Carbon Neutral Cambridge Response to Barton Greenway consultation

We strongly support the principle and overall scheme, but propose a few detailed improvements

Grantchester Street/ driftway Junction

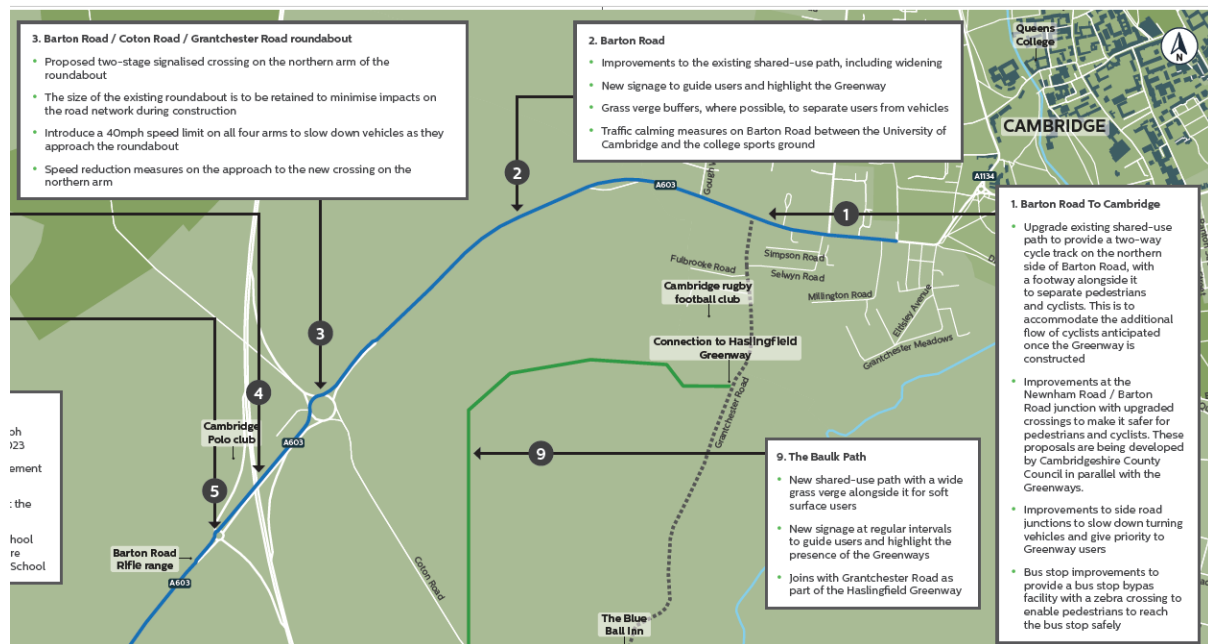
The Grantchester Street/ Driftway junction is very heavily used by both cycles and pedestrians, and this should be encouraged and enabled by careful design, thus helping reduce Greater Cambridge's carbon emissions.

Lots of cargo bikes, cycle child-trailers, and young children on bikes, particularly at school time. Newnham croft shops are popular with Barton road commuters and those in the wider local area. Residents of Newnham Croft tend to be heavy users of bikes for travel within the City. Lots of people visit Grantchester Meadows to walk or picnic and to walk or cycle up the permissive path across the meadows to Grantchester. This is a key spot for active travel, so careful design of the junction to encourage it is important.

Cyclists and pedestrians typically come out of Grantchester Street, (having crossed onto the EAST pavement at the raised platform opposite the Coop) then either cross the Driftway to join the cycleway towards the city centre (or, less frequently, out along Barton Road), or turn down the Driftway to join the cycleway across Lammas land towards Trumpington Road and the station. And vice versa Both are heavily used.

It's important that the crossing over the Driftway is wide enough that several cyclists and pedestrians can wait side by side on the pavement until it's safe to cross. Simple changes like replacing the proposed length of 110mm kerb upstand with a wider length of dropped kerb would help substantially.

The tiny length of on-street cycleway that's proposed on the WEST side of Grantchester Street, between the raised pavement and the traffic lights, should ideally be replaced by a wider shared use pavement on the EAST side between the raised table and the Driftway. For most people, this will be much more useful.

Barton road

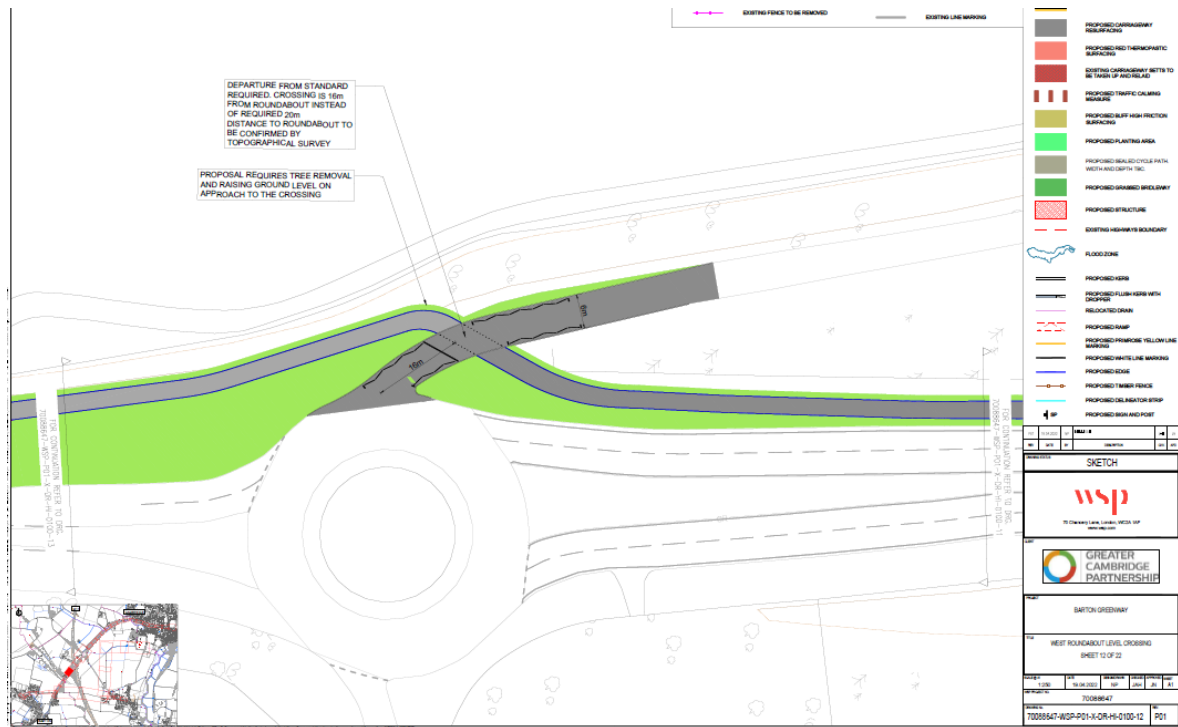
Retain mature trees, unless absolutely essential to remove them, even if it results in a local narrowing of the width of the path for say 1m round each tree. This local narrowing is often done for other street furniture, why not for trees?
